TECHNICAL BULLETIN
Bell Helicopter **TEXTRON**
A Subsidiary of Textron Inc.

NO 407-99-17

SUBJECT: **NEW TAIL ROTOR INSTALLATION 407-012-100-109, INTRODUCTION OF.**

HELICOPTERS AFFECTED: 407, S/N 53000 through 53350.

Figure 1. Modification of the Interconnect Bellcrank Assembly

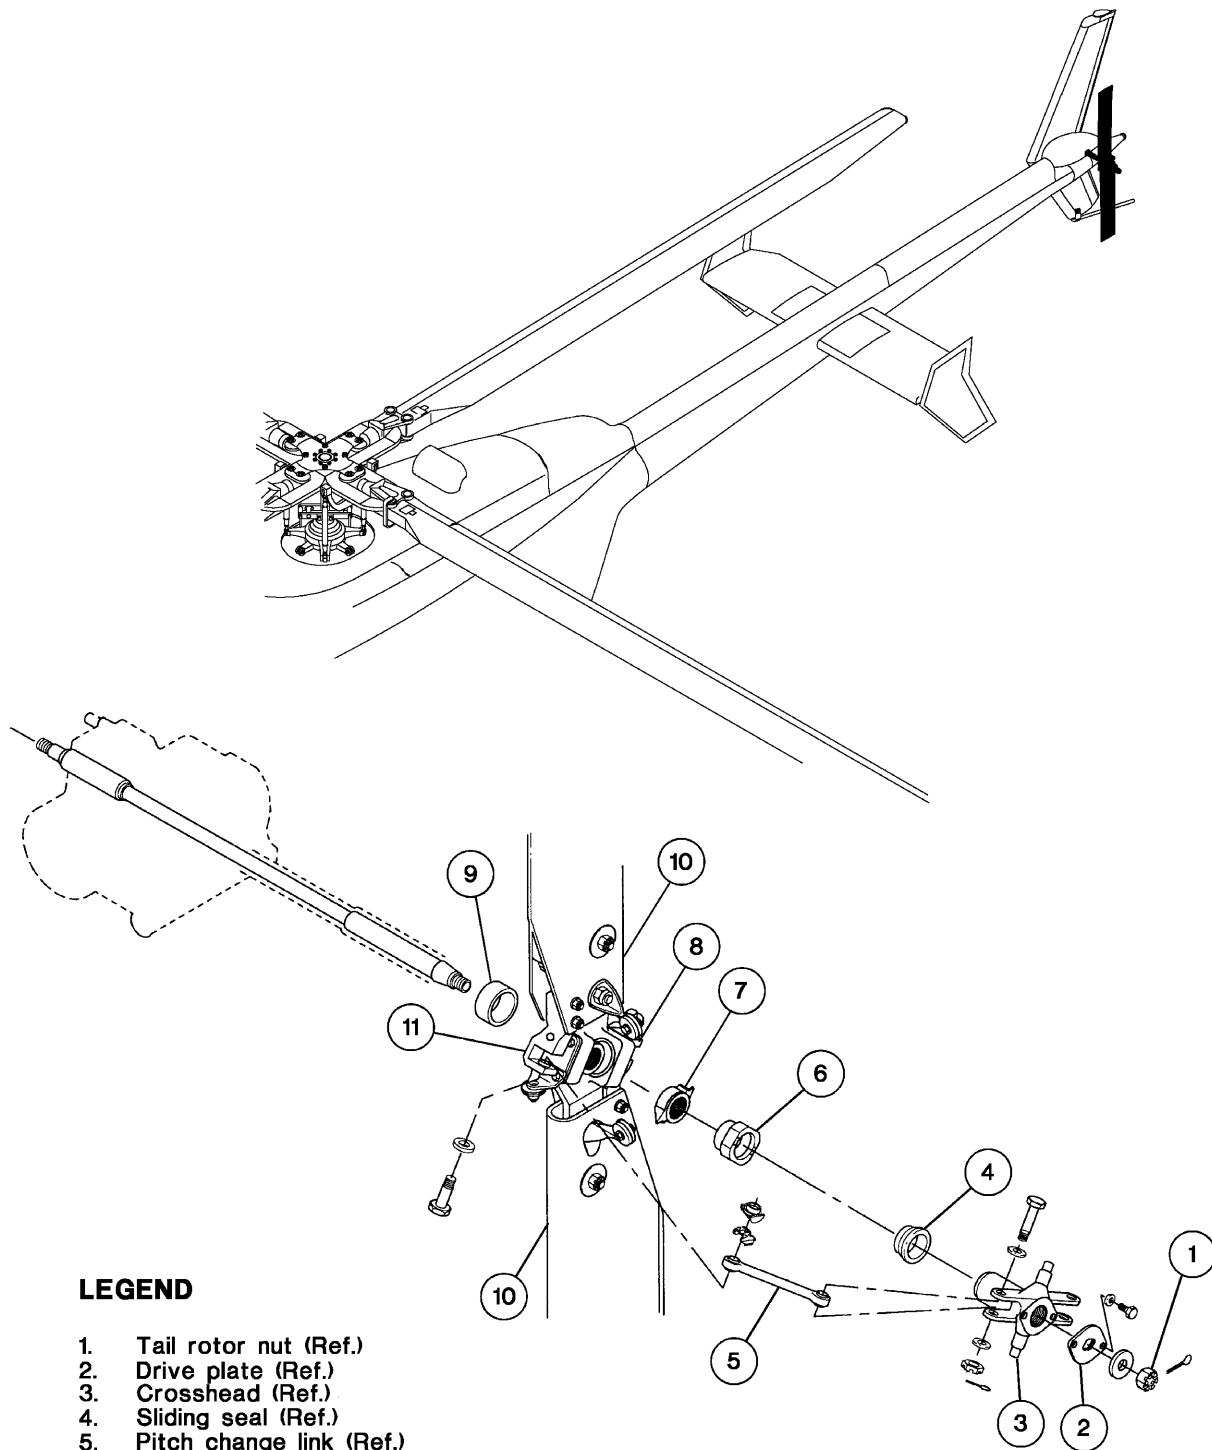
1. Remove the interconnect bellcrank (refer to BHT-407-MM, Paragraph 67-102).
2. Install the new stop as follows (refer to Figure 1):
 - a. Put the stop (3, Figure 1) on the bellcrank (1). Make sure that the edges (Note 1) on the stop (3) are flush with the related edges on the bellcrank (1).

- b. With the stop in position, make sure that the insert (4) of the stop fits flush into the bellcrank stop radius (Detail A). If the fit is not correct, sand the irregular edges on the stop insert (4) only until you get the correct fit.

- c. Put the stop (3) on the bellcrank (1) per Steps a. and b. above. Clamp the stop (3) to the bellcrank (1). Use the pilot holes in the stop as a guide; drill two No. 40 drill size holes through the bellcrank. Increase the dimension of the two holes to a No. 30 drill size. Drill countersinks for the heads of the rivets on the stop.

- d. Remove the stop (3) and deburr the holes in the stop (3) and the bellcrank (1). Prime all bare material.

- △1 Edges of stop (3) must be flush with corresponding edges of the bellcrank.
- △2 Install stop (3) with adhesive (C-317) and MS20426AD4-9 rivet (2 REQ'D).
- △3 If fit of stop insert (4) to bellcrank (2) stop radius is not correct, sand the irregular edges on the stop insert (4) only until you get the correct fit.
- △4 Seal edges of stop (3) and bellcrank (1).

Figure 2. Old Hub and Blade Assembly – Removal/Installation

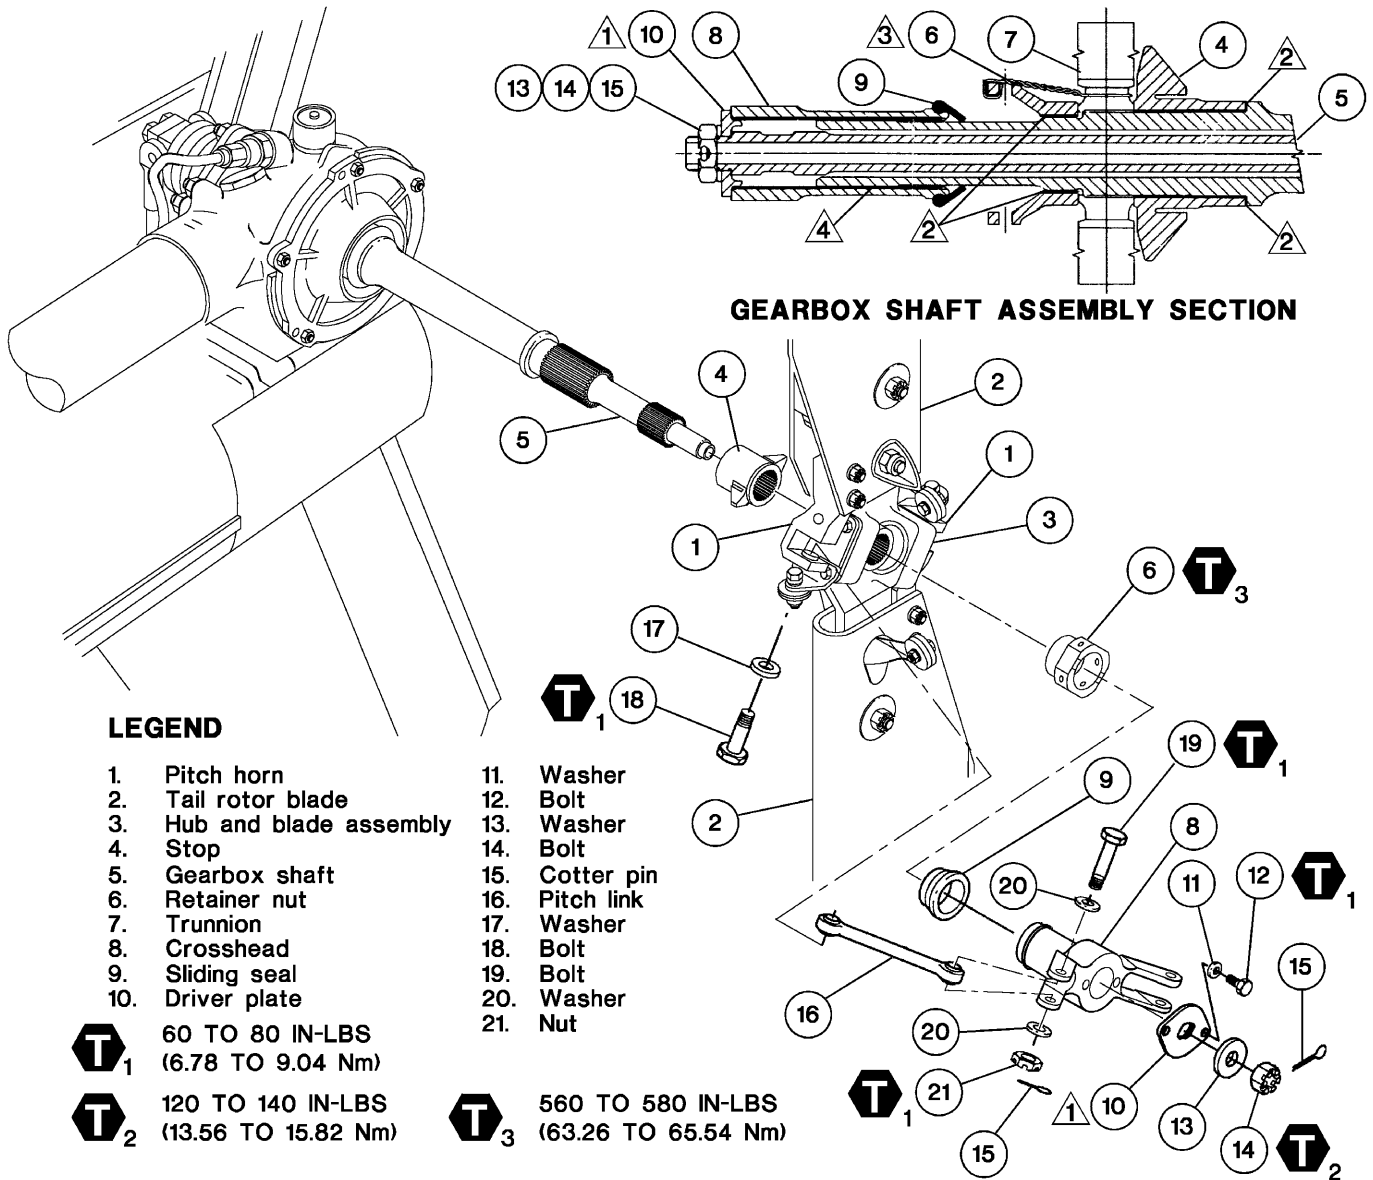
1. Remove the tail rotor nut (1, Figure 2), the crosshead (3), and the pitch change links (5). Discard the crosshead (3). Keep the tail rotor nut (1), the driver plate (2), the sliding seal (4), the pitch change links (5), and all hardware for subsequent installation. Refer to BHT-407-MM-8, Paragraphs 67-140, 67-144 and 67-148.

2. Remove the tail rotor retainer nut (6), the support (7), hub and blade assembly (8), and the spacer (9). Discard the tail rotor retainer nut (6), the support (7), and the spacer (9). Keep the hub and blade assembly (8) for subsequent installation. Refer to BHT-407-MM-7, Paragraph 64-5.

3. Remove the two pitch horns (11) that are installed on the tail rotor blades and discard them. Refer to BHT-407-MM-7, Paragraph 64-35.
4. Install the new pitch horns (1, Figure 3) on the tail rotor blades. Refer to BHT-407-MM-7, Paragraph 64-39.

Figure 3. New Hub and Blade Assembly - Removal/Installation

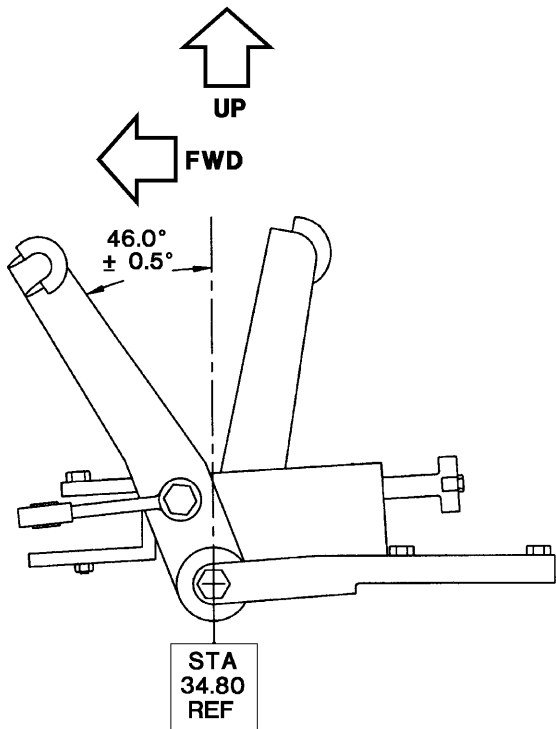
6. Install the hub and blade assembly (3) as follows (refer to Figure 3):
 - a. Apply a layer of corrosion preventive compound (C-104) to the splines of the support (4) and the gearbox shaft (5).

Place the stop (4) with the splined end outboard as shown in Figure 3.

- b. Install the new stop (4) on the gearbox shaft (5).
- c. Apply a layer of corrosion preventive compound (C-104) to the splined trunnion (7) of the hub and blade assembly (3) and the gearbox shaft (5).
- d. Install the hub and blade assembly (3) on the gearbox shaft (5).
- e. Apply a coat of corrosion preventive compound (C-104) to the threads and mating surface of the retainer nut (6).
- f. Install the retainer nut (6) on the gearbox shaft (5).
- g. Use the crowfoot and tighten the retainer nut (6) .
- h. Use lockwire (C-405) and safety the retainer nut (6) to the trunnion (7).
- i. Install the crosshead (8) as follows:
 - 1) Put the lip of the sliding seal (9) in the groove of the crosshead (8).
 - 2) Apply a layer of grease (C-001) on the splines of the gearbox shaft (5).
 - 3) Put the crosshead (8) on the gearbox shaft (5).
- j. Install the driver plate (10) as follows:

- 1) Put driver plate (10) in position on the crosshead (8).
- 2) Install the washers (11) and the bolts (12) that hold the driver plate (10) to the crosshead (8).
- 3) Tighten the bolts (12) .
- 4) Use lockwire (C-405) and safety the bolts (12) together.
- 5) Install the washer (13) and the nut (14) on the control tube (5).

- 6) Tighten the nut (14) .
 - 7) Use a cotter pin (15) to safety the nut (14).
- k. Install the pitch links (16) as follows:
- 1) Put the pitch link (16) between the pitch horn (1) and the crosshead (8).
 - 2) Install the washer (17) and the bolt (18) that hold the pitch link (16) in the pitch horn (1).
 - 3) Tighten the bolt (18) .
 - 4) Safety the bolt (18) with lockwire (C-405).

Make sure that the bolt head (19) is on the leading side of the crosshead. The bolts must be installed with the head in the direction of rotation of the tail rotor assembly.

- 5) Install the bolt (19), the washers (20), and the nut (21).
- 6) Tighten the nut (21) .
- 7) Safety the nut (21) with cotter pin (15).

Figure 4. New Directional Control Rigging Procedure (Sheet 1 of 2)

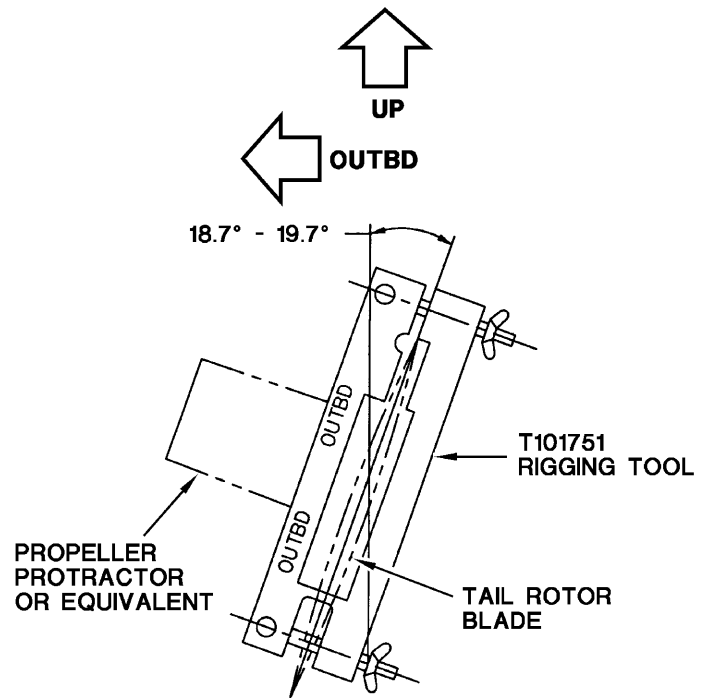
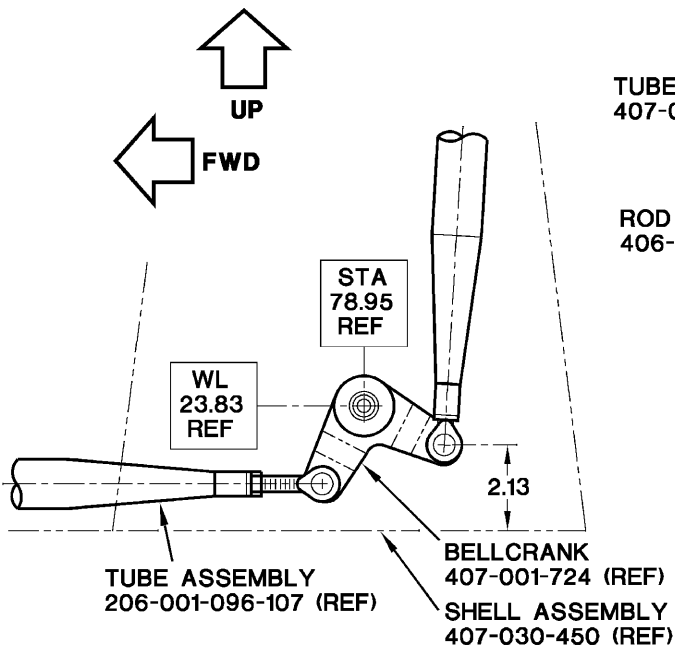
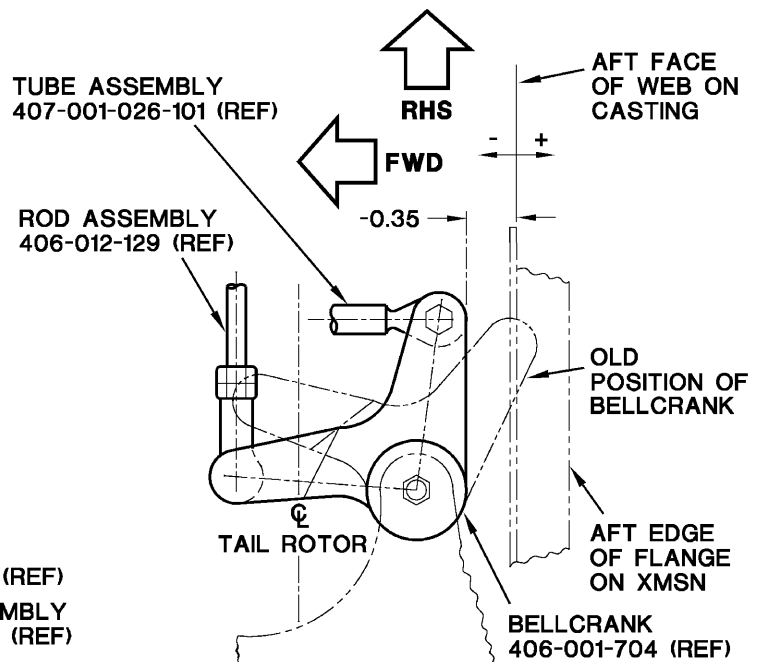
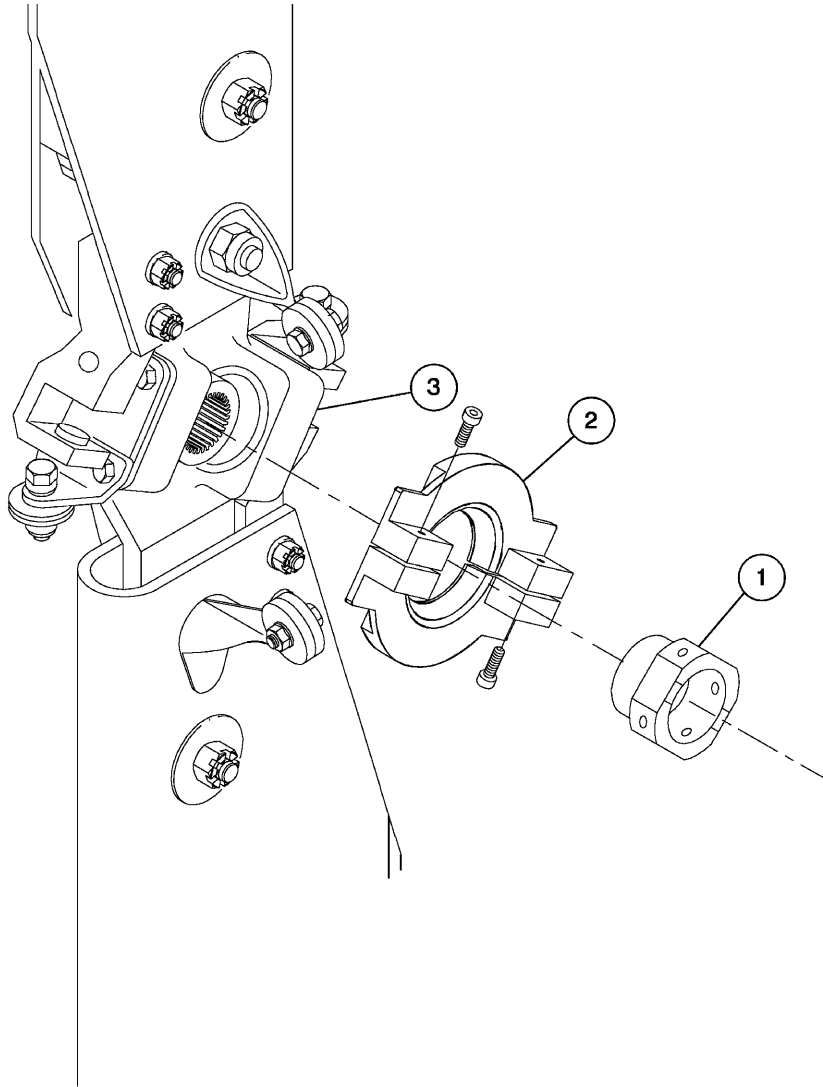
- 1) Make sure that the directional pedal angle (BHT-407-MM-8, Paragraph 67-94, Step 2 and Figure 67-24, Detail A) is **now 46° +/- 0.5°** with the stop installed. The value without the stop was 56°. If the dimension is not **46° +/- 0.5°**, adjust the value.

- 2) Make sure that the dimension between the floor and the bellcrank (BHT-407-MM-8, Paragraph 67-94, Step 5 and Figure 67-24, Detail B) is **now 2.13 inches** with the stop installed. The value without the stop was 1.79 inches. If the dimension is not **2.13 inches**, adjust the dimension.

- 3) Make sure that the dimension between the bellcrank and the aft face of web on the casting (BHT-407-MM-8, Paragraph 67-94, Step 5 and Figure 67-24, Detail C) is **now -0.35 inch** with the stop installed. The value without the stop was + 0.15 inch. If the dimension is not **-0.35 inch**, adjust the dimension.

- 4) Install the workaid (Figure 4, Sheet 2) on the tail rotor assembly.
 - 5) Make sure that the mean tail rotor blade angle (BHT-407-MM-8, Paragraph 67-25, view B-B) is **now 18.7° to 19.7°** with the stop installed. The value without the stop was 27.5° to 28.5°. If the mean angle is not **18.7° to 19.7°**, adjust it (refer to BHT-407-MM-8, Paragraph 67-94, Step 18).

NEW PEDAL ANGLE 46.0° ± 0.5°

**VIEW LOOKING FORWARD
NEW T/R BLADE ANGLE 18.7° - 19.7°**
